PERMIT

SEWAGE DISPOSAL SYSTEM

Dave King	·		_ IS PERMITTED TO I	INSTALL	ALTER X
ADDRES 2845, 2944 Rt. 97			PHONE	410 977	2144
SUBDIVISION Glenwood Nursury	LOT	a	DAD 145 2949	Route 97	
PROPERTY OWNER	Glenwood 2) 45 Rd	Nursery			
ADDRESS	Glenwood,	Maryland 2	21/38		
SEPTIC TANK CAPACITY GALLONS					
NUMBER OF BEDROOMS				,	
SQUARE FEET PER BEDROOM			•		
LINEAR FEET OF TRENCH REQUIRED	<u> </u>				
REPAIR - PURPOSE - REPLACE EXISTING Call for inspection when location.	G SEPTIC TANK tank is in p	(. lace so that	a sanitarian d	can recommend	l size and
		:			
PLANS APROVED BY Amy McMillen				DATE : 9	-27-1999
COVER NO WORK UNTIL INSPECTED AND APPROVED					
NEITHER THE HOWARD COUNTY COUNCIL NOR THE HEAL	LTH DEPARTMENT IS	RESPONSIBLE FOR	THE SUCCESSFUL OPE	ERATION OF ANY SYS	STEM
NOTE: CLEANOUT REQUIRED EVERY 70 FEET OF SEV ACCEPTABLE	VER LINE AND/OR A	KT 90° SWEEPS IN	LINES FROM HOUSE T	TO DRAIN FIELDS, 9	00. ELBOMS NOT
NOTE: ALL PARTS OF SEPTIC SYSTEMS (I.E. TANK, DI AUTHORIZED)	STRIBUTION BOX T	RENCHES) TO BE 1	00 FEET FROM WELL	(UNLESS OTHERWI	SE SPECIFICALLY

HOWARD COUNTY HEALTH DEPARTMENT

BOYERS EQUIP SHOP SHOP + MOBIL 6 HORE PAST DISPLAY RETAIL AREA &

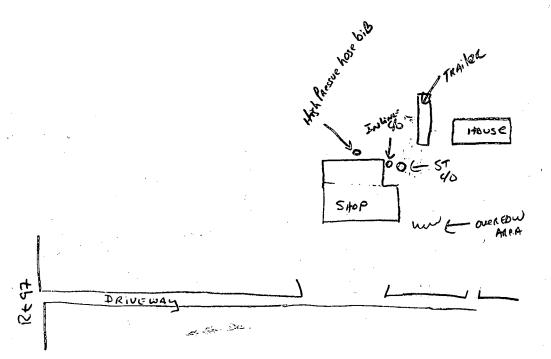
4-20-58- Prublem - high Pressure hose bib Adjacent TO ST LEAKS.

RUNDAF FROM THE BIB AND THE USE OF THE MOSE TO

WASH TRUCKS CHANNELS TO AND PUDDIES AT THE INGINE

90. The INGINE C/O CAP IS CRACKED AND WATER ENSENS

TANK, MOST GKELY REASON for premature Strailure.

Recom. Repair ingine 60 TO 6" Above grade, Repair)

Replace Trench
